To: Plan Holders
From: Katy Turney for Bob Huguenard
Date: October 30, 2017
Re: City of Franklin, Tennessee
Franklin WRF Modifications & Expansion Project - COF Contract No. 2017-0264
Addendum No. 3

**CITY OF FRANKLIN, TENNESSEE
FRANKLIN WRF MODIFICATIONS & EXPANSION PROJECT
COF CONTRACT NO. 2017-0264 / CDM SMITH PROJECT NO. 14915-96594-WRF**

**ADDENDUM NO. 3
October 30, 2017**

PROCESS AND INSTRUMENTATION DIAGRAM
DENITRIFICATION FILTERS

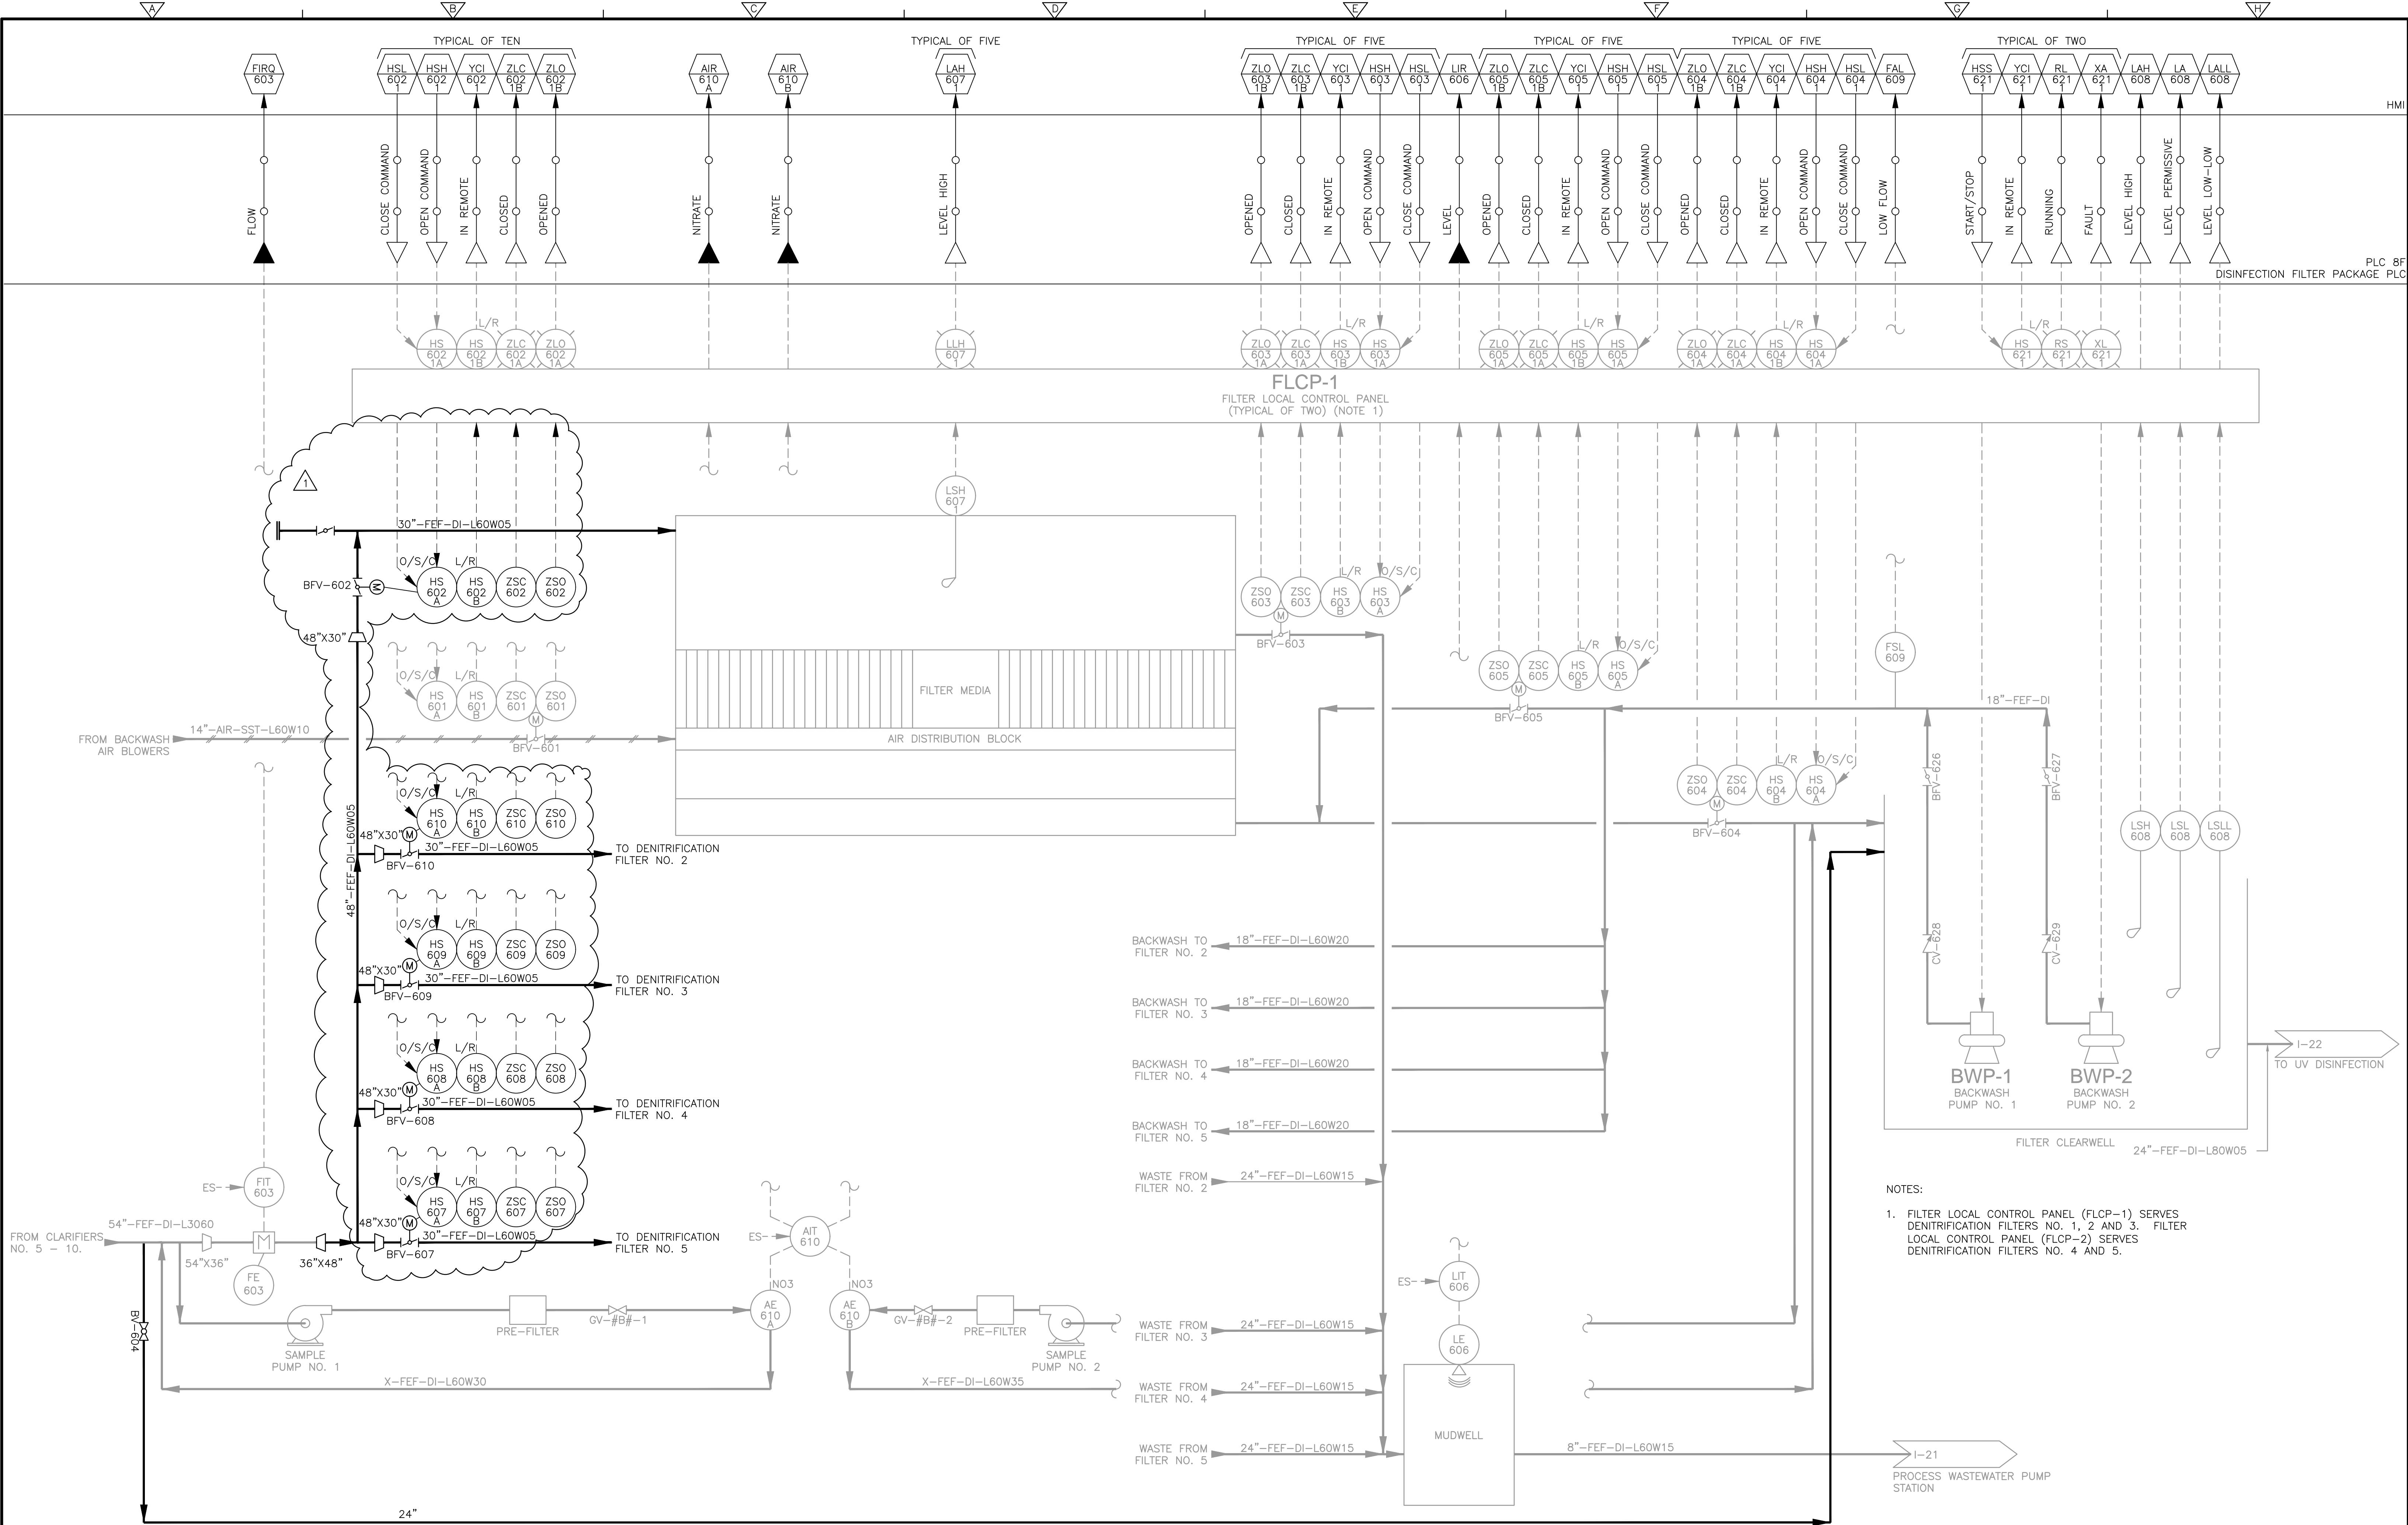
Response: Please refer to the changes in this Addendum.
2. Request: Drawing I-20 indicates a new 30” butterfly valve with an EMO actuator (tag BFV-602). Please clarify where this valve is located on the M-series drawings.

Response: Please refer to the changes in this Addendum.
3. Request: In section 00300 “Schedule of Prices” bid item L “Excavation below normal grade and backfill with structural fill” the Unit is in Tons. This is in conflict with section 01025 3.02 M.3.a. where is references price per cubic yard. Please clarify. If the Unit is to be in tons please provide unit weight for the conversion.
